# SERVICE BULLETIN

## USE OF THE ROTAX<sup>®</sup> SUPPLIED AIRBOX FOR ALL ROTAX<sup>®</sup> ENGINE TYPES 912 A / F (SERIES) SB-912-044

Standardization of the engine type 912 Series.

Use of the ROTAX<sup>®</sup> supplied airbox for all ROTAX<sup>®</sup> engine type 912 (Series).

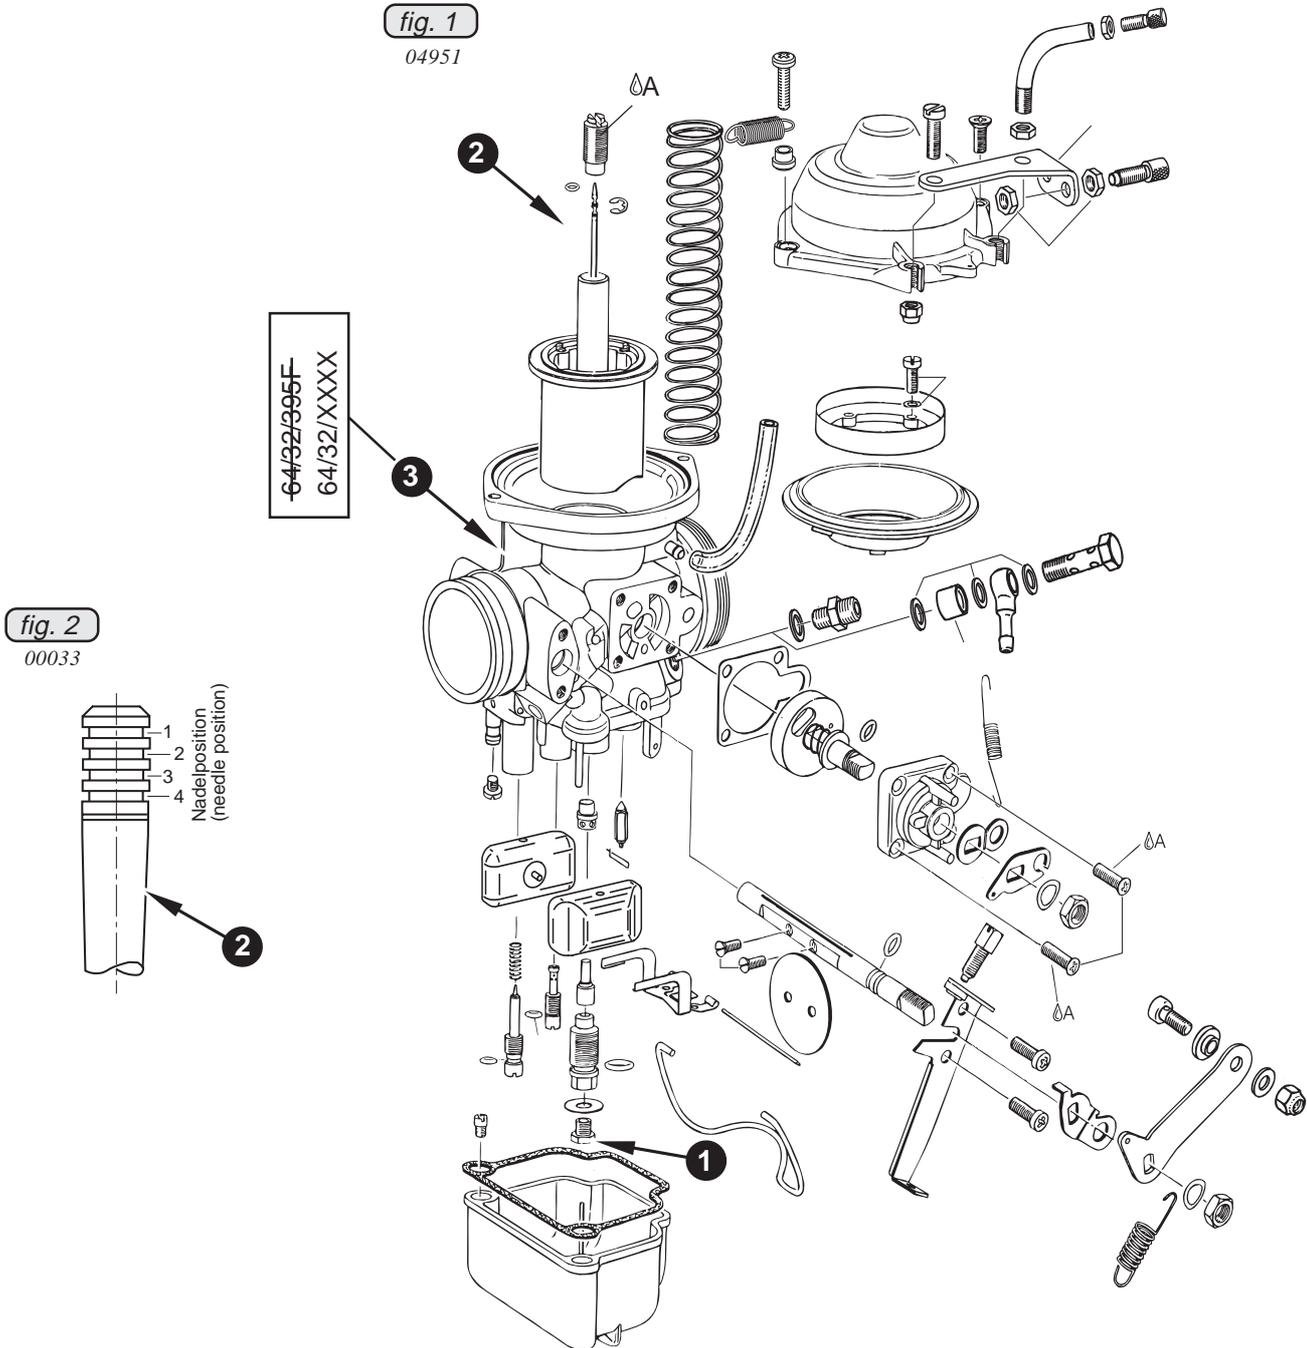
- Replace the existing main jet 158 (1) of carburetors 1/3 and 2/4 with a main jet 155 (1); refer to the applicable Maintenance Manual.
- Do the modification of the main jet (1) and thus change the model phase by applying the BING designation of type 64/32/416 B= carburetors 1/3 part no. 888804, 64/32/417 B= carburetors 2/4 part no. 888809 to the carburetor housing(3). Cross out the existing BING designation of type.
- Adjust the jet needle position (2) of carburetors 1/3 and 2/4 to position 3; refer to the applicable Maintenance Manual.

■ **CAUTION:** The jet needle position described above is the basic adjustment for the airbox part no. 867756.

fig. 3

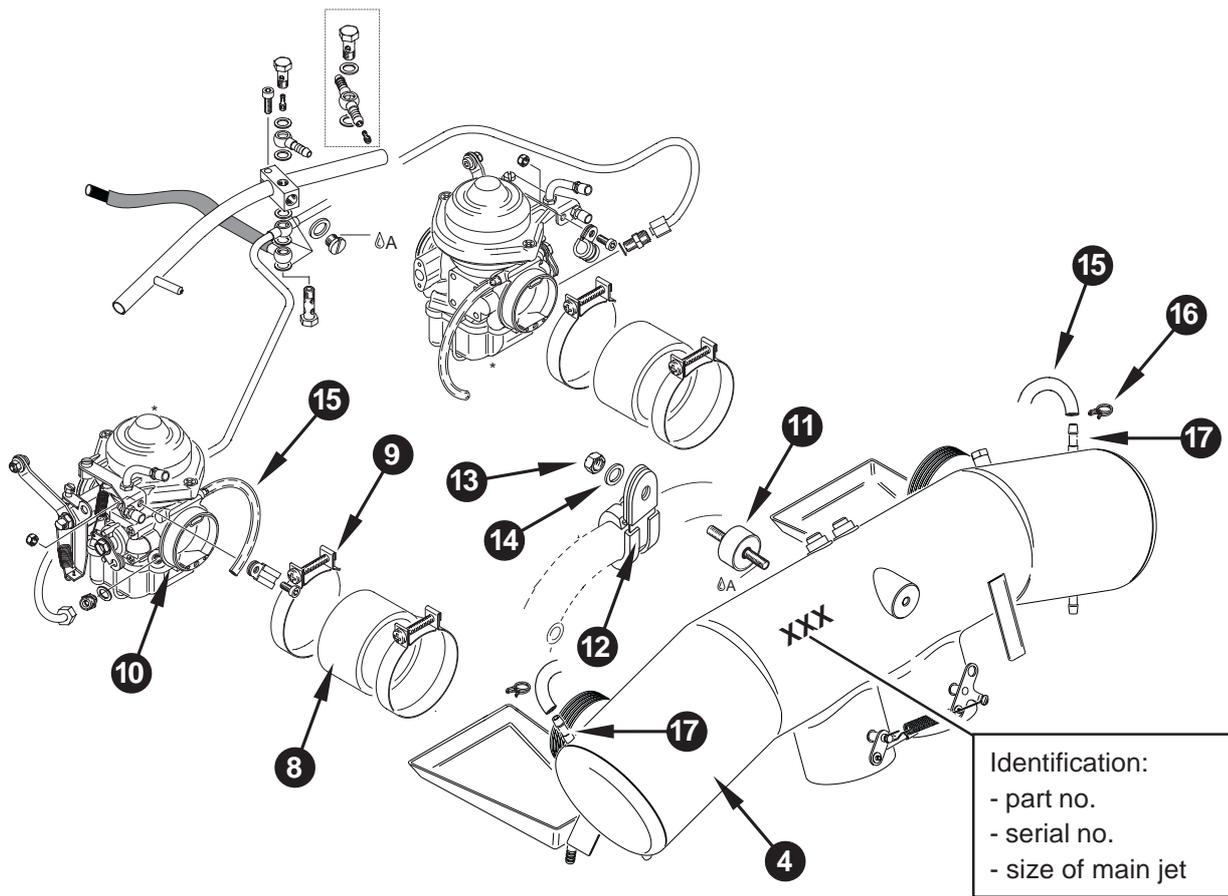
- Attach the two symmetrical drip trays (5) to the drip tray holder with hex. screws M5x12 (6) and washer and nut M5 (7).

- Slightly coat threads of rubber buffer (11) with LOCTITE 221 film and screw into airbox at the front. Tightening torque 3 Nm (27 in.lb.)

fig. 4

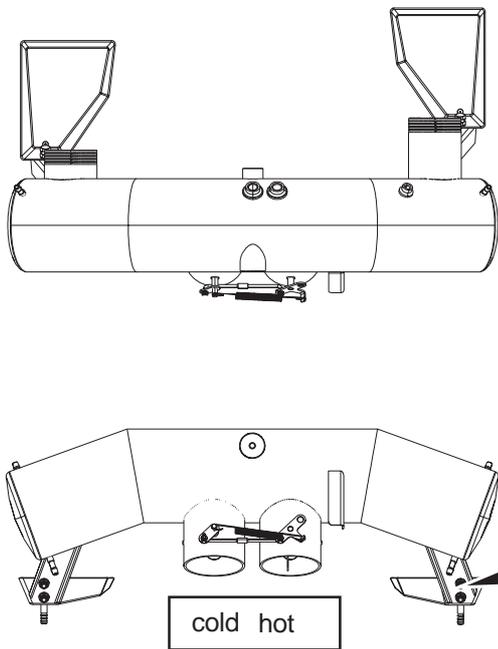
- Put pre-assembled airbox (4) in position with the connection tubes (8) and 2 hose clamps (9) each as far as they go on the connections of the carburetor (10). Afterwards adjust airbox such that it is positioned parallel to the engine suspension frame/ignition housing and is level. Attach the airbox with the 2 hose clamps (9).

◆ **NOTE:** Make sure that the air connections of the airbox are correctly connected for fresh air and pre-heated air. (see fig. 4)

fig. 5

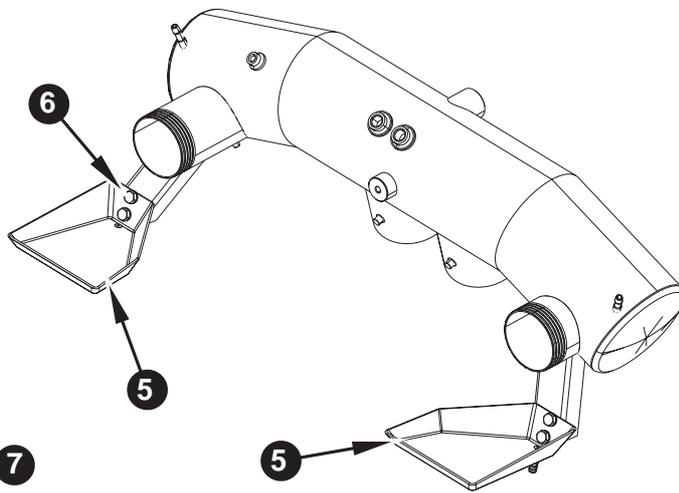
◆ **NOTE:** The airbox has been factory pre-assembled as far as possible.  
(see fig. 4 and fig. 5, drawing shows asymmetrical drop trays)
